CM CLARIFICATION #004

PROJECT: CNE Tahlequah Casino

ADDENDUM # 001

Tahlequah Casino Addendum #01 summary

SLAB PLAN

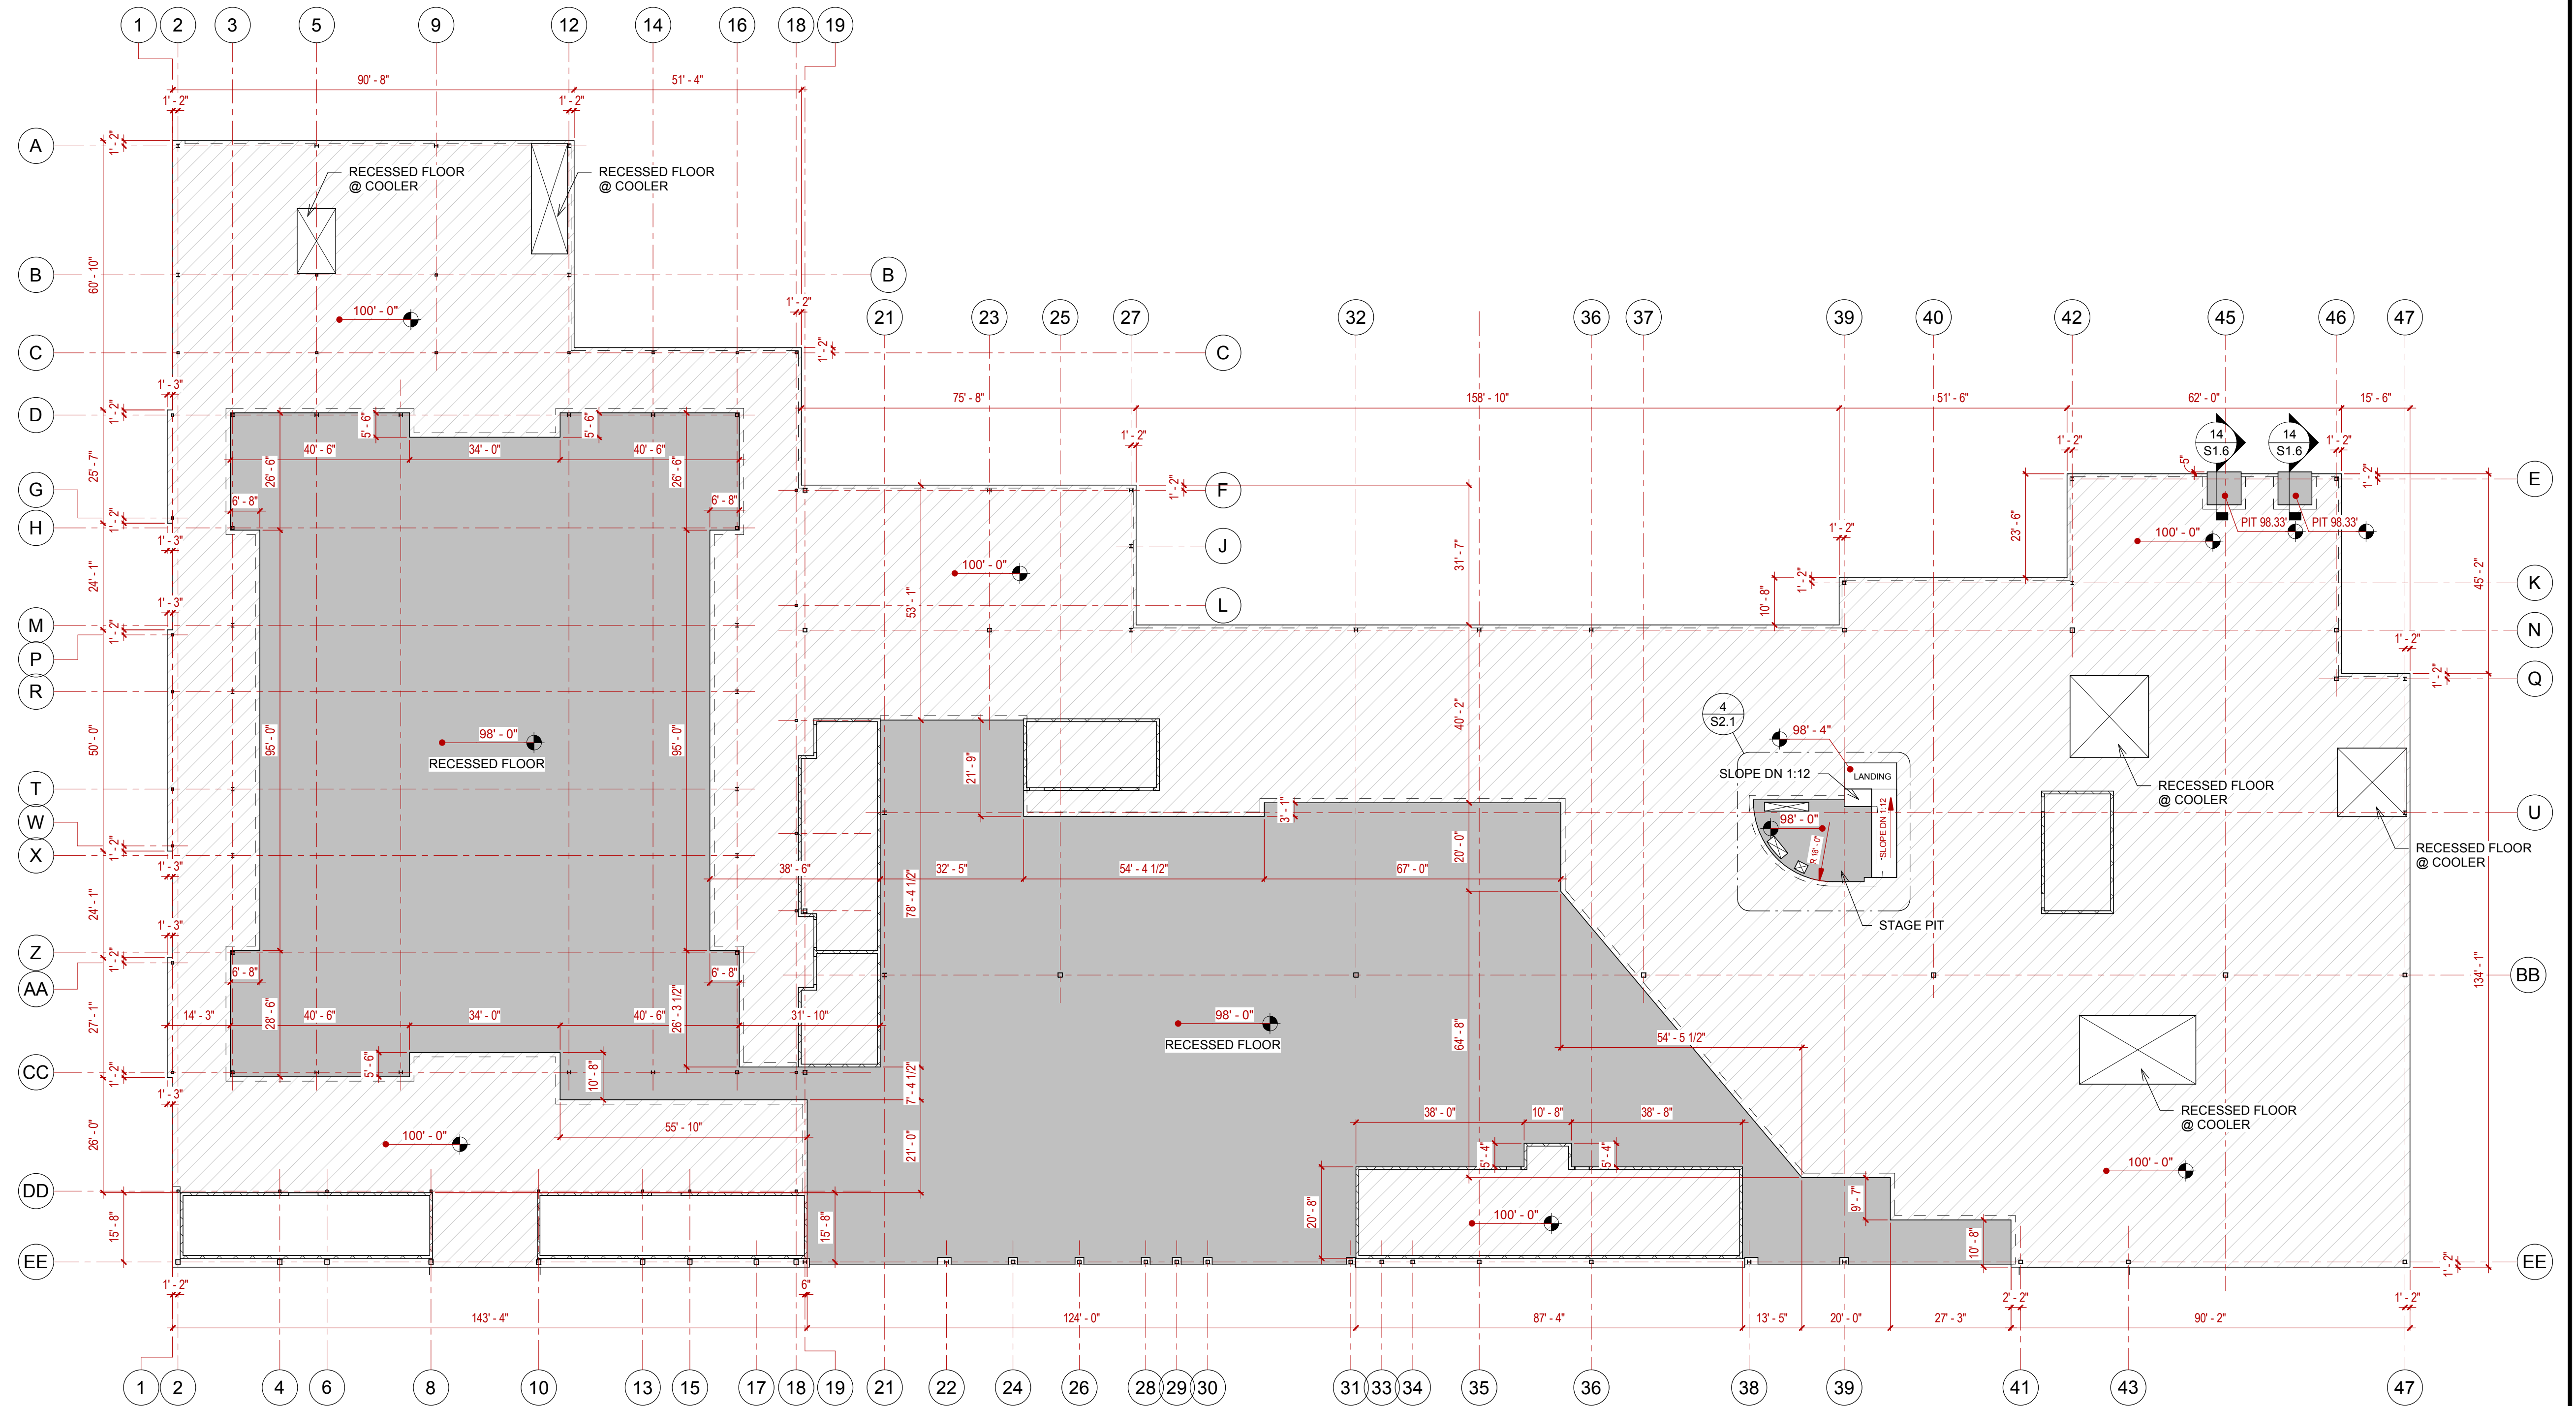
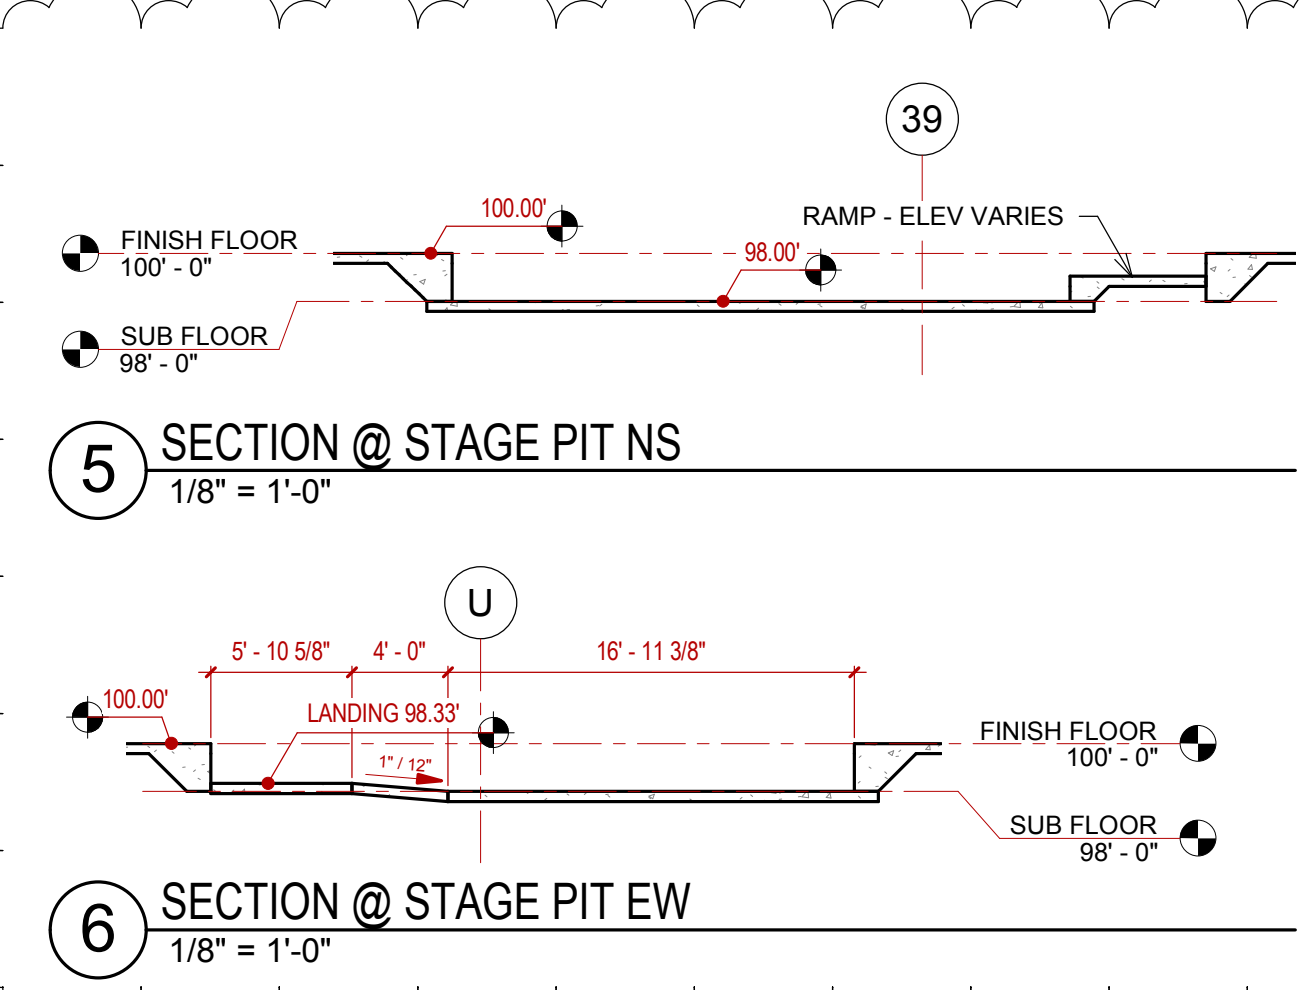
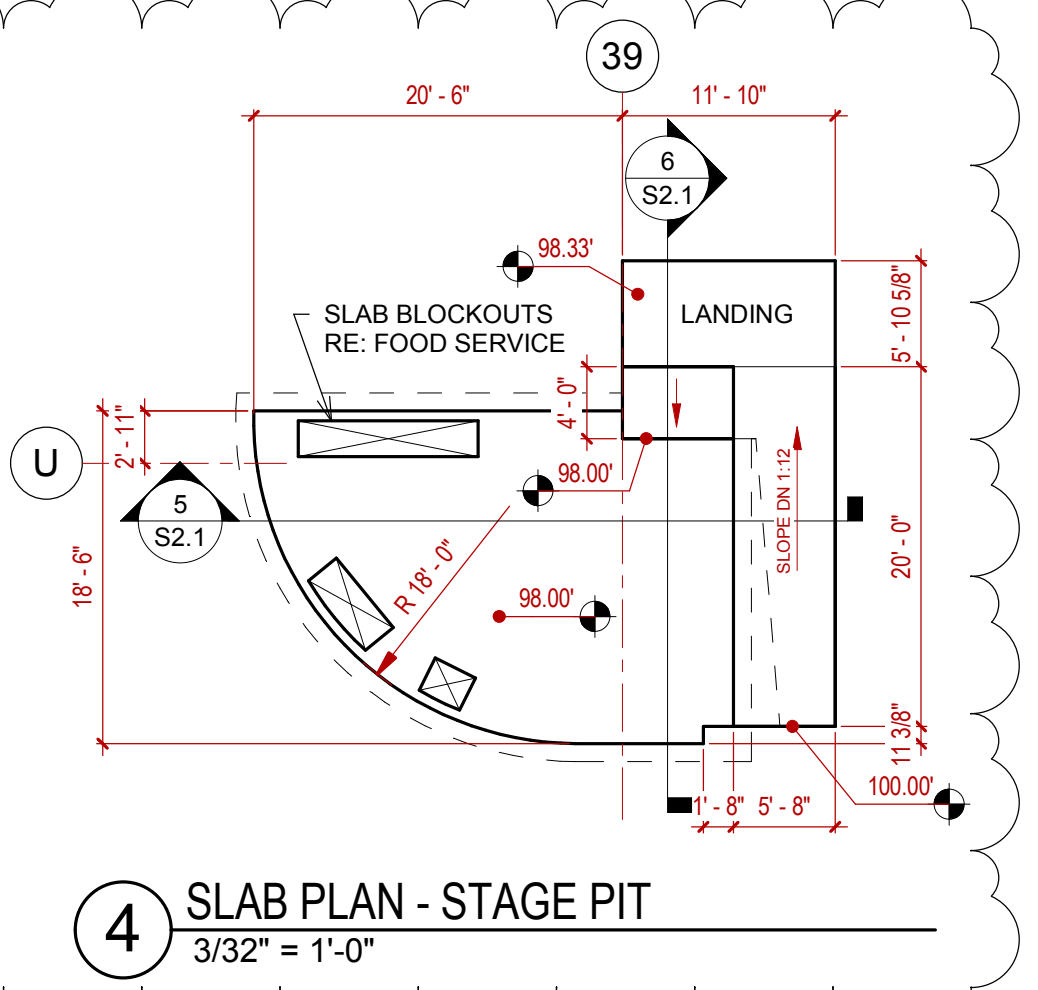
S1.5	Added sheet S1.5
S1.6	Added sheet S1.6
S1.7	Added sheet S1.7
S2.1	<ul style="list-style-type: none"> • Added enlarged stage pit plan and sections. • Added pit for dock levelers.
S3.1	<ul style="list-style-type: none"> • Revised roof deck to galvanize. • Revised column sizes.
S3.2	<ul style="list-style-type: none"> • Moved brace elevation from Y/BB-19 to U/BB-21 • Moved frame line 'DD' 1" east • Revised roof deck to galvanize. • Removed column @ U-19 & U-27.
